NOTICE OF ADDENDUM

ADDENDUM NO. 2

CITY OF MADISON
NAKOOSA TRAIL FLEET/FIRE/RADIO SHOP FACILITY

A-503

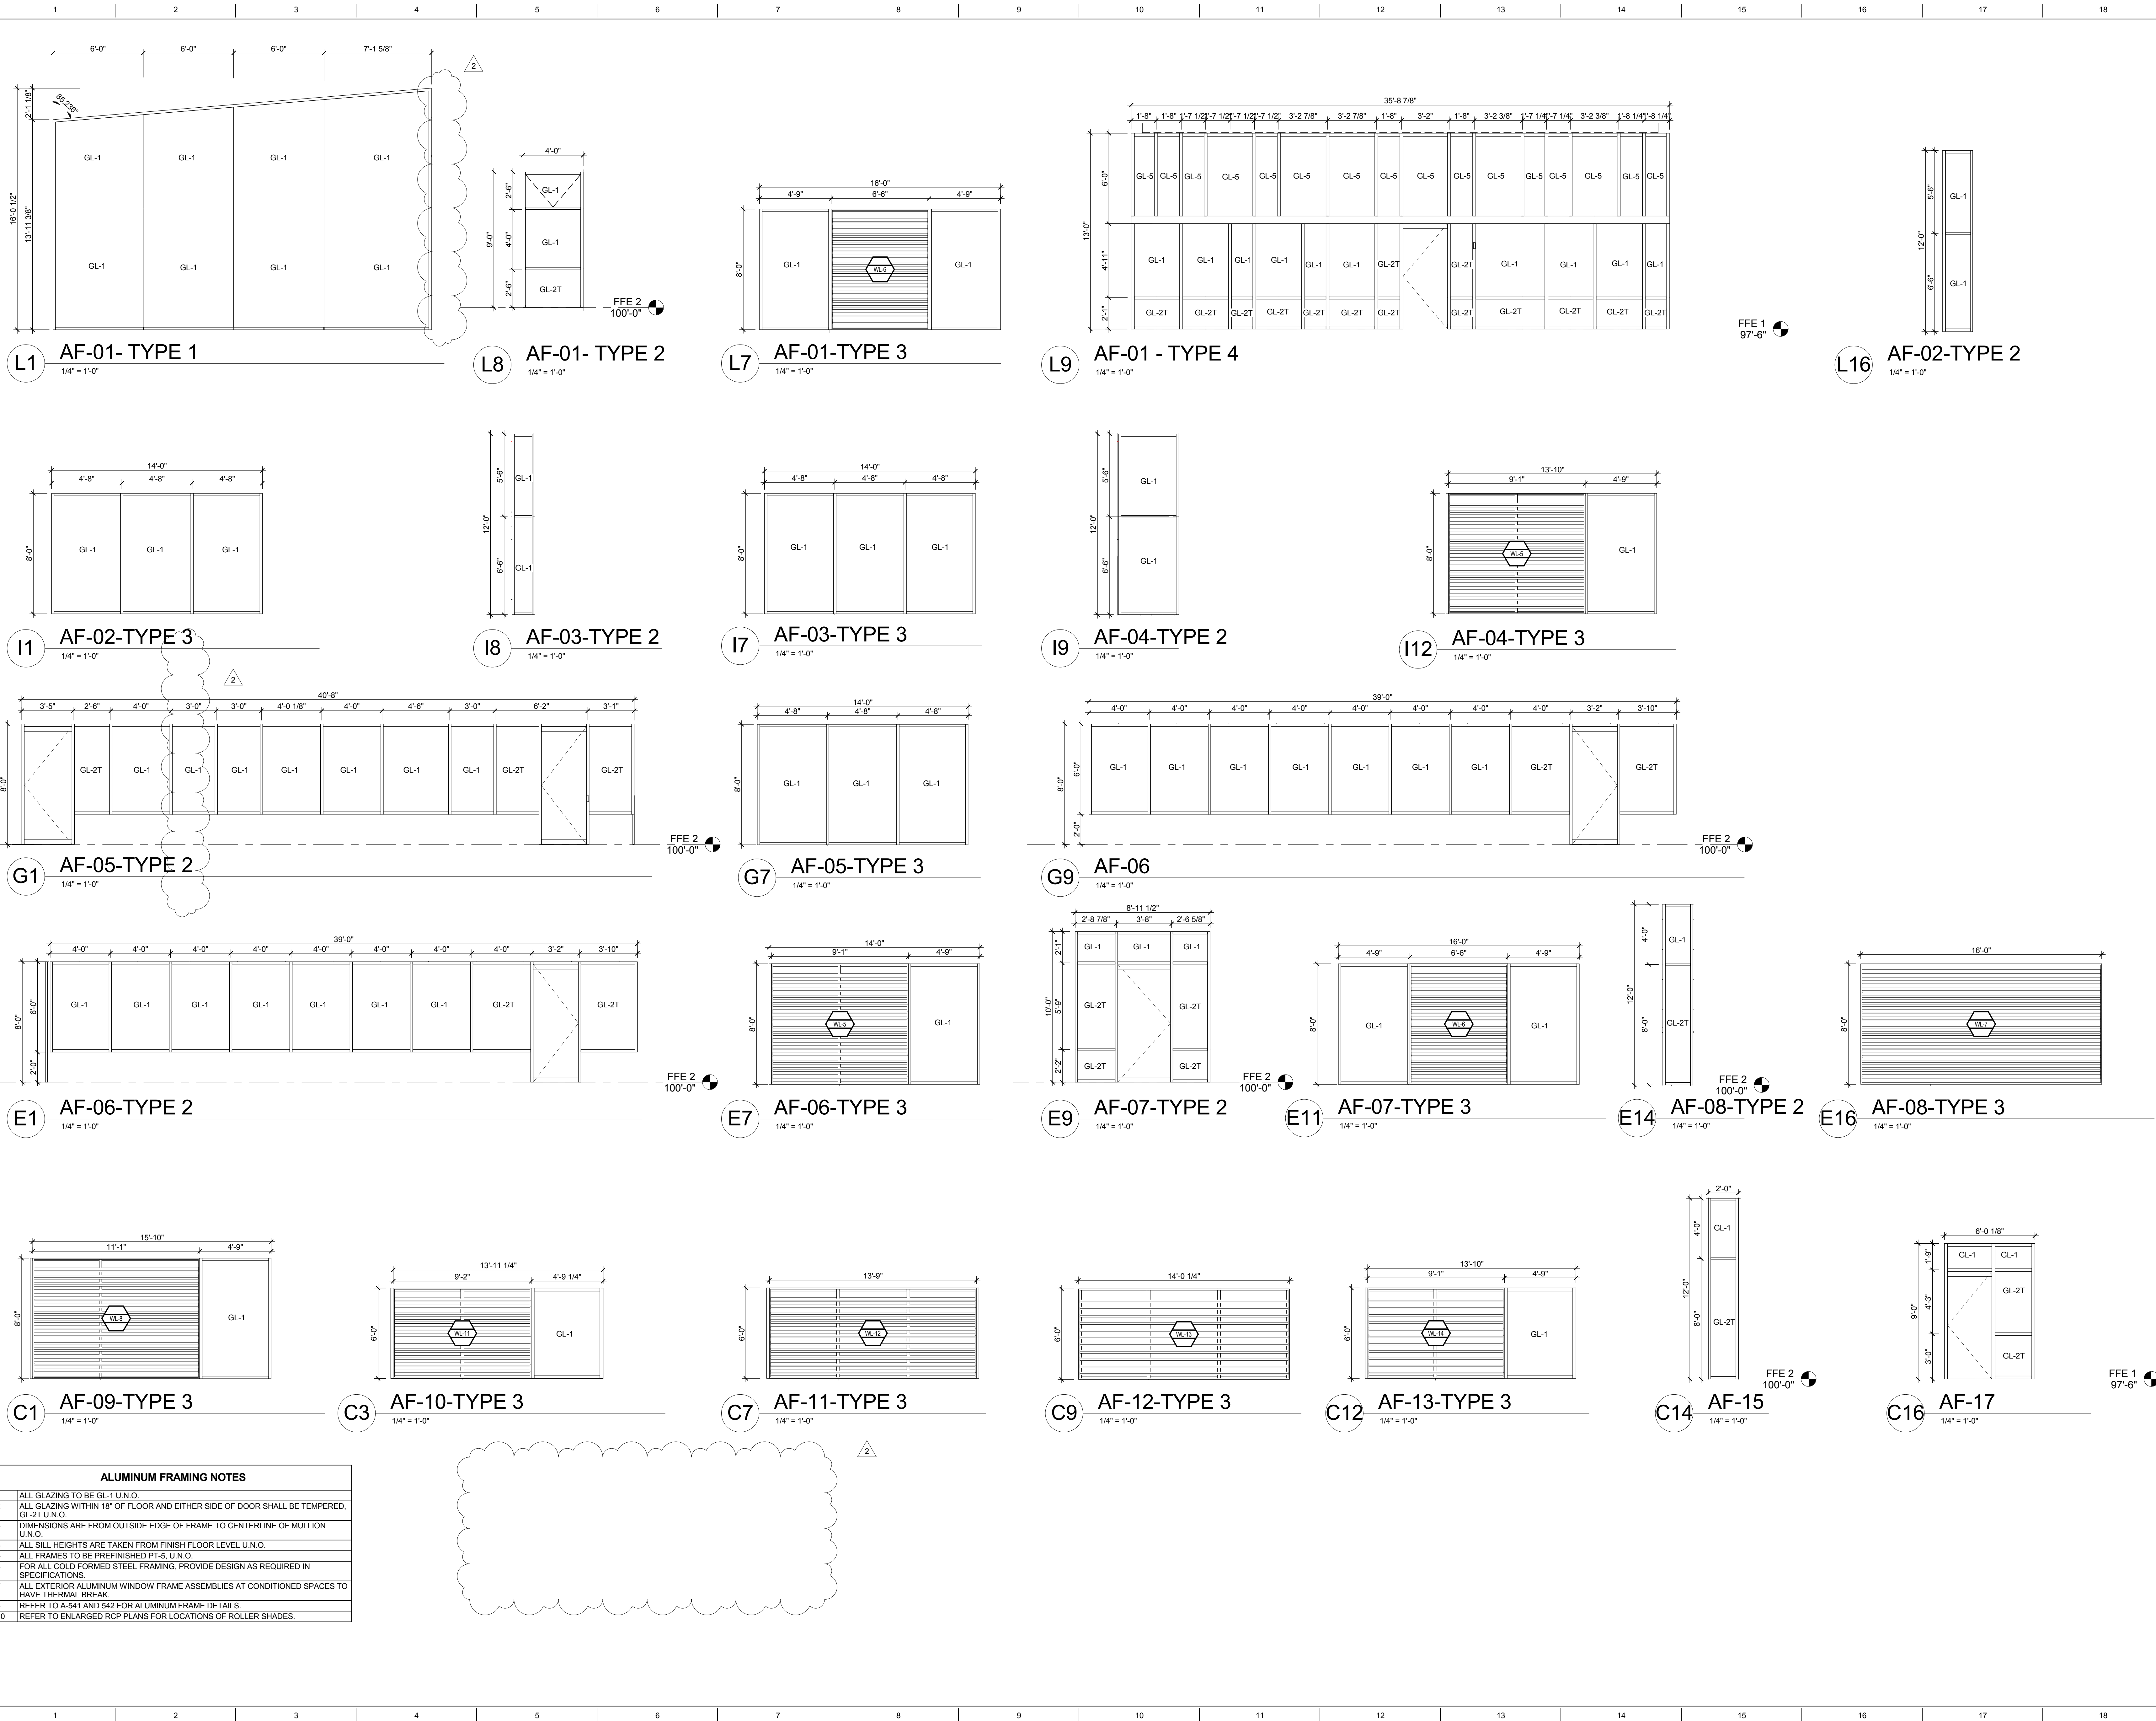
- CC. **MODIFIED** A-503 BL WINDOW ELEVATIONS to revise BL-19 to simplify and reduce size of glazing, add linework to represent radiant floor mounting box, revise glazing types on all BL drawings, and remove glazing type schedule.

S-101A

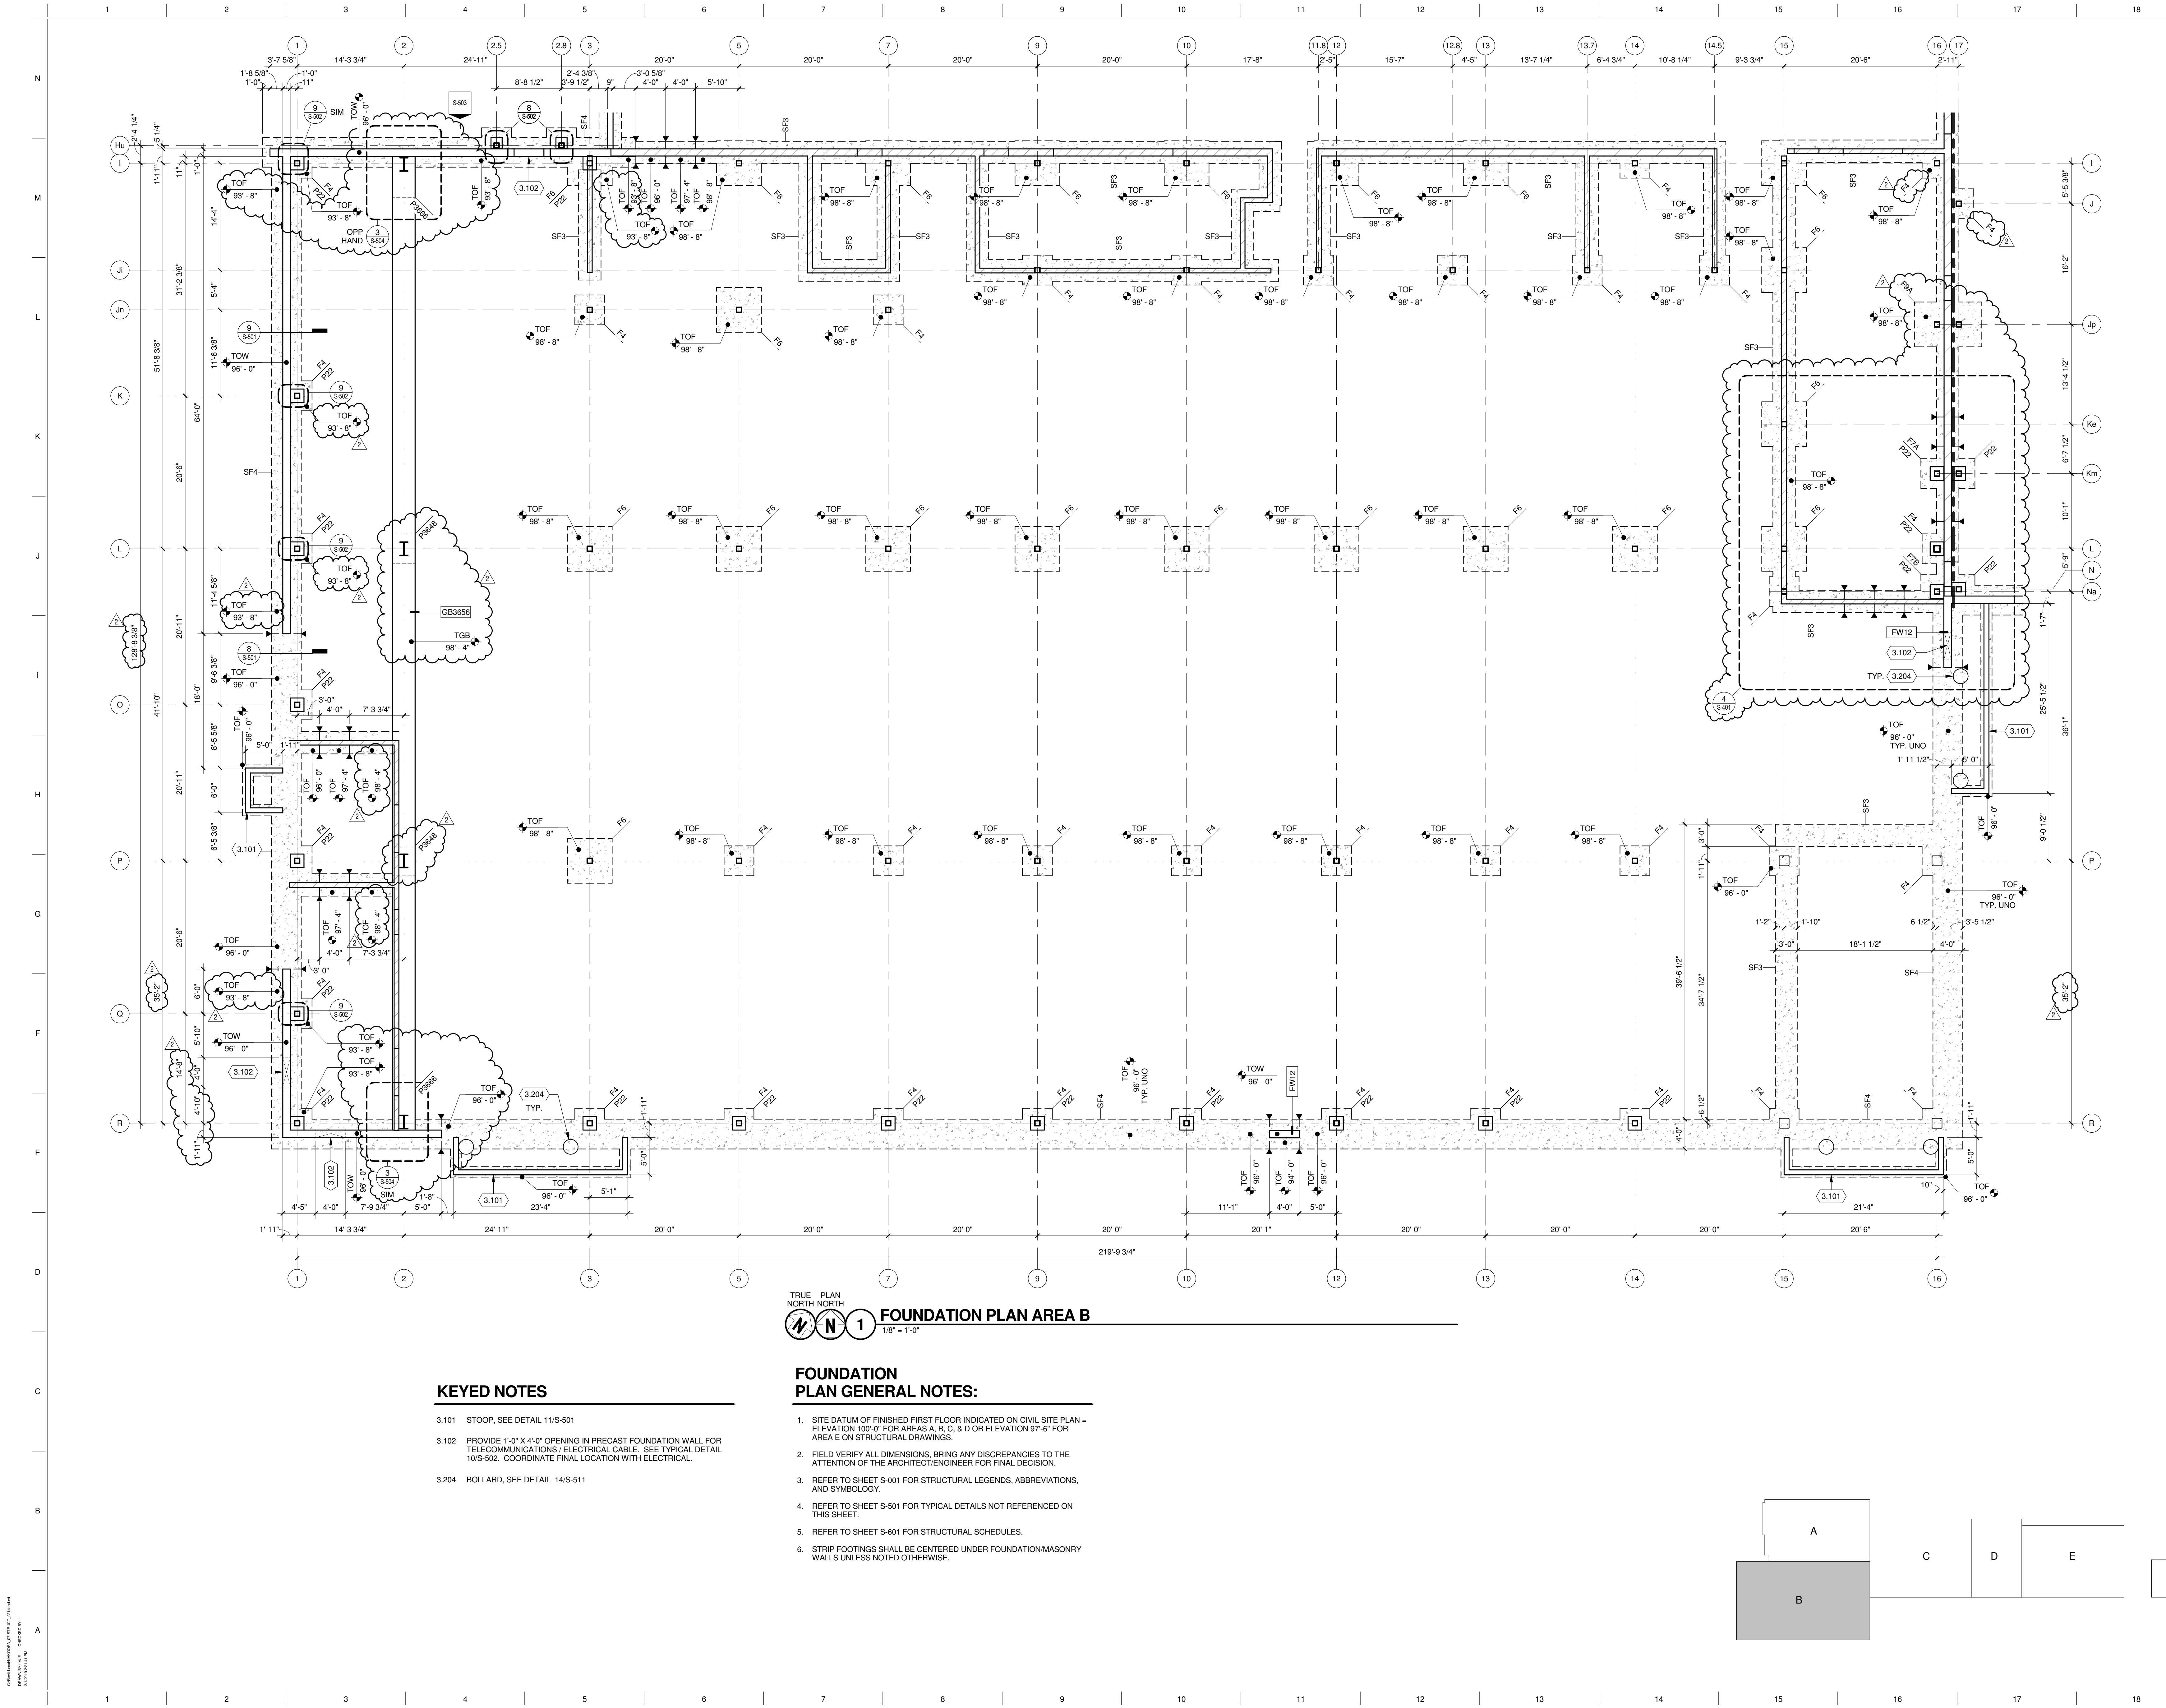
- RR. **MODIFIED** S-101A FOUNDATION PLAN AREA A to revise foundations as indicated in attached drawings.

S-101C

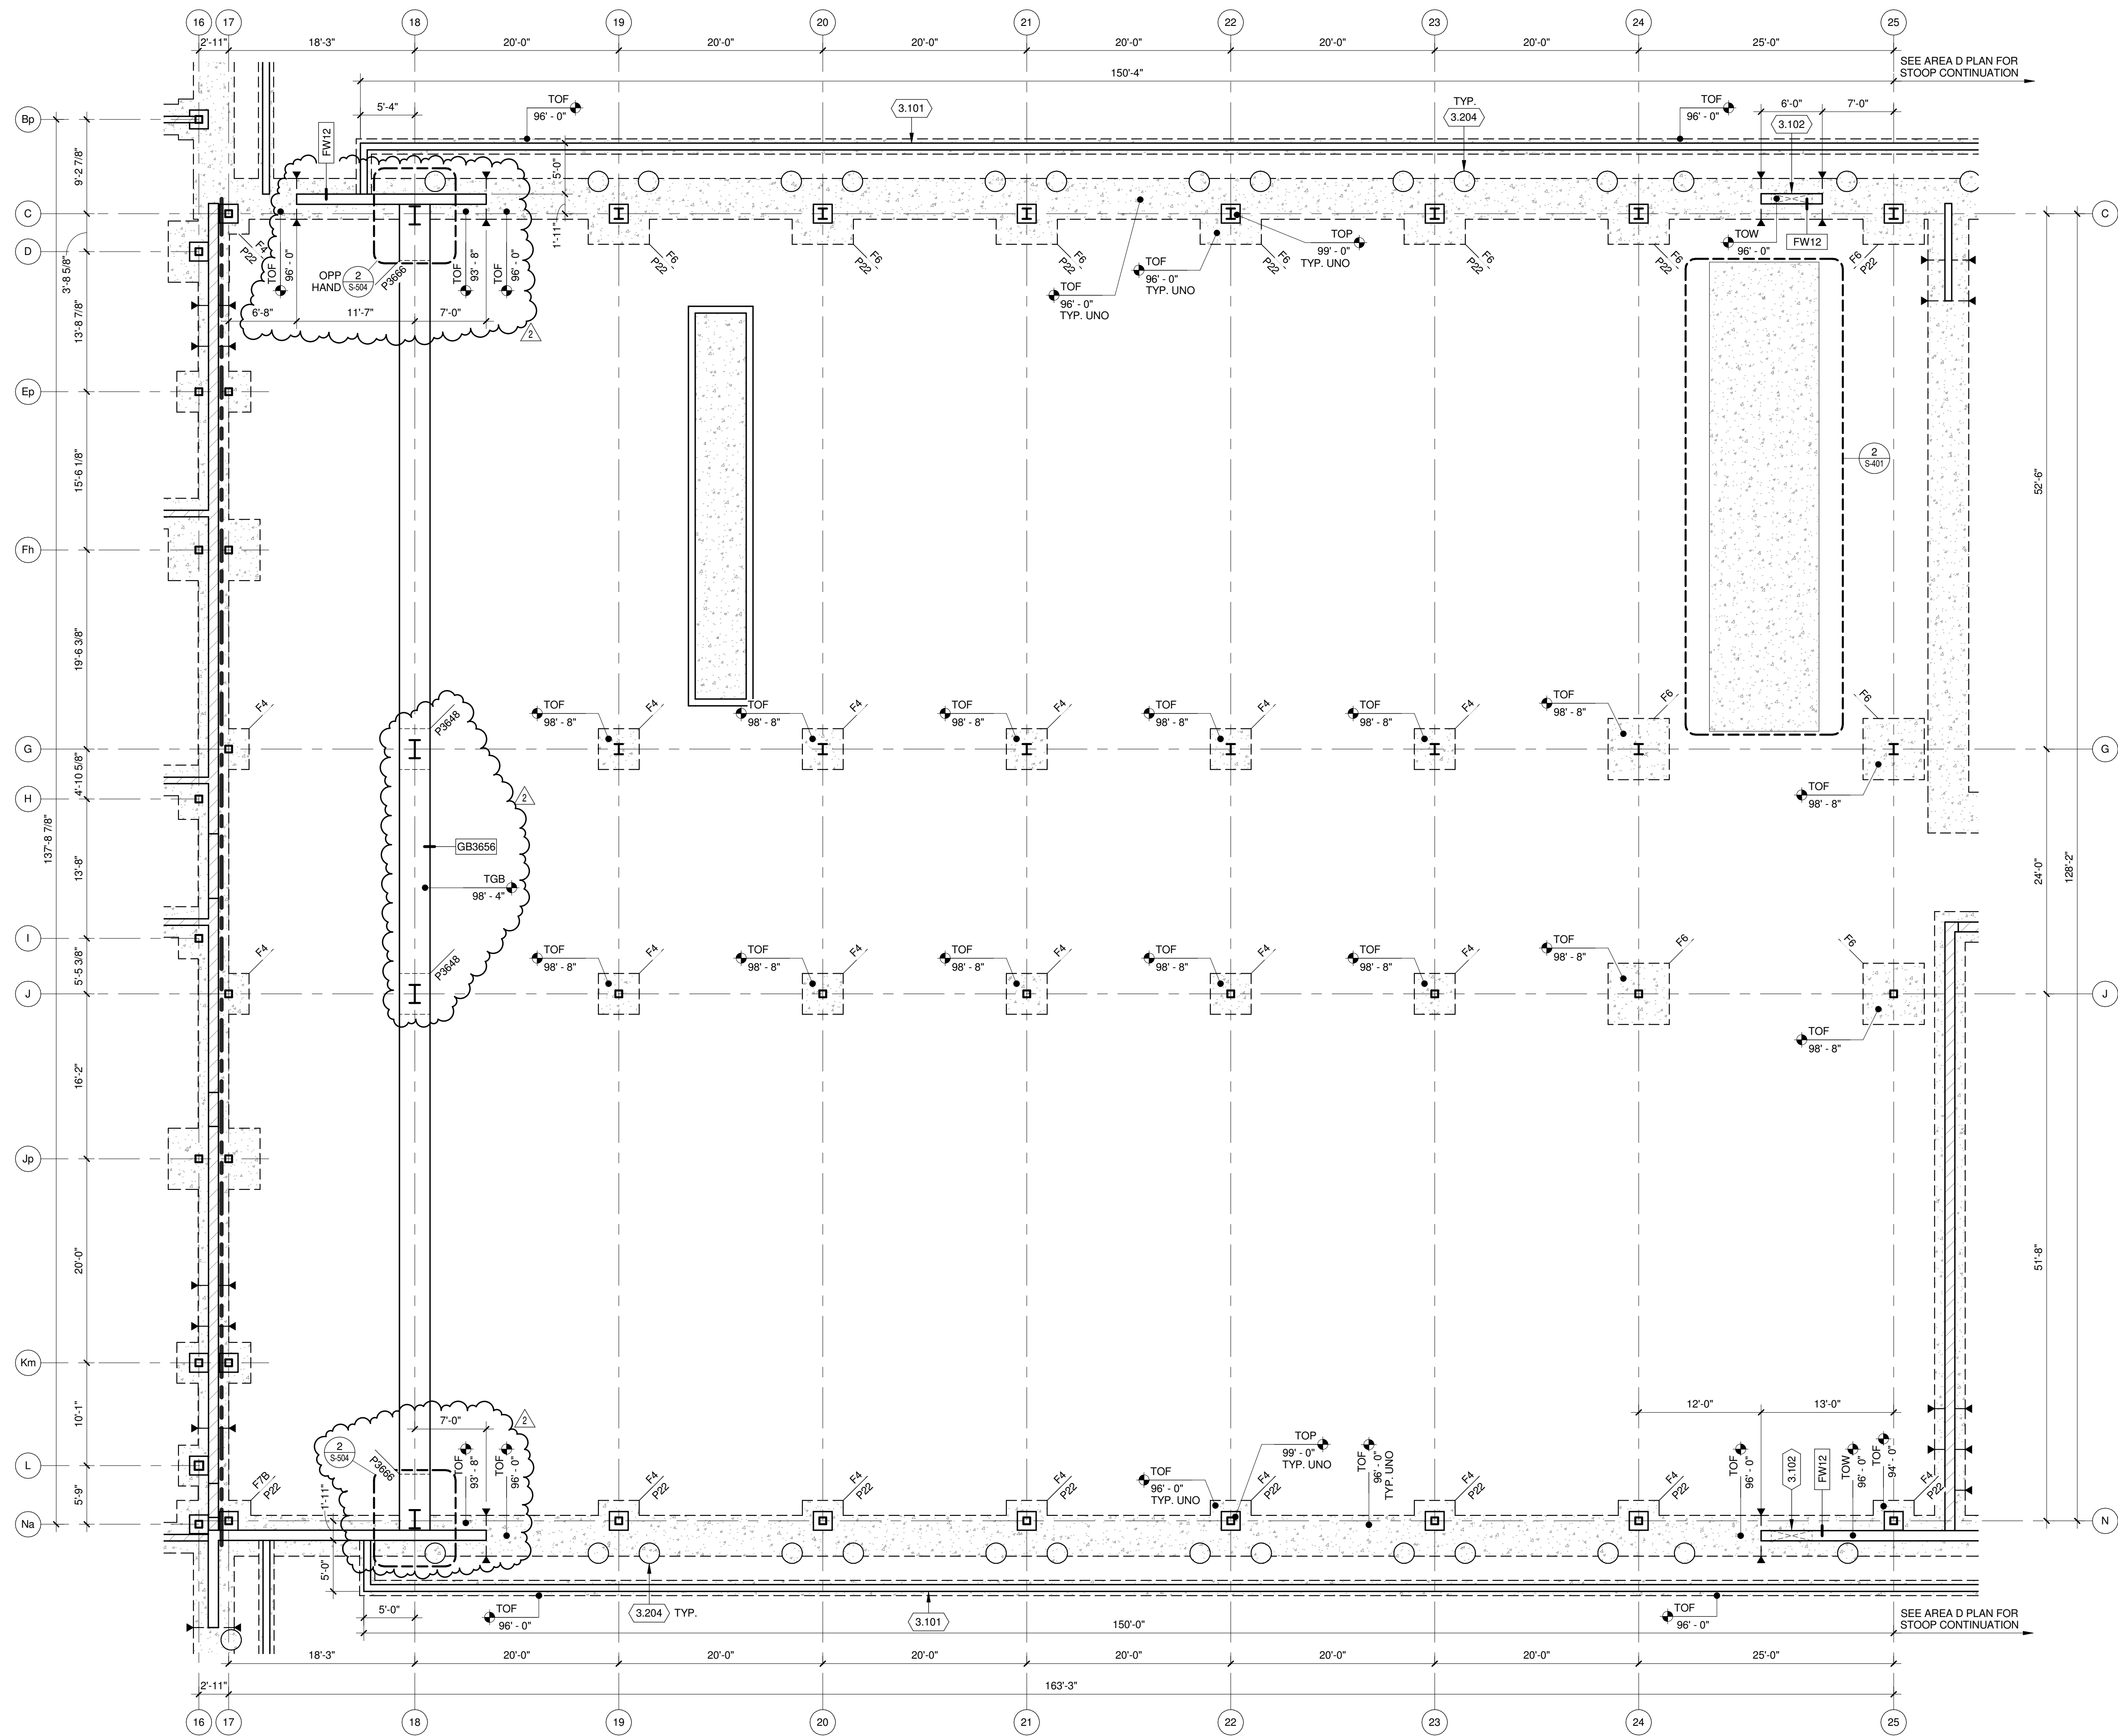
- TT. **MODIFIED** S-101C FOUNDATION PLAN AREA C to revise foundation as indicated.
- UU. **MODIFIED** S-101D FOUNDATION PLAN AREA D to revise foundation as indicated.
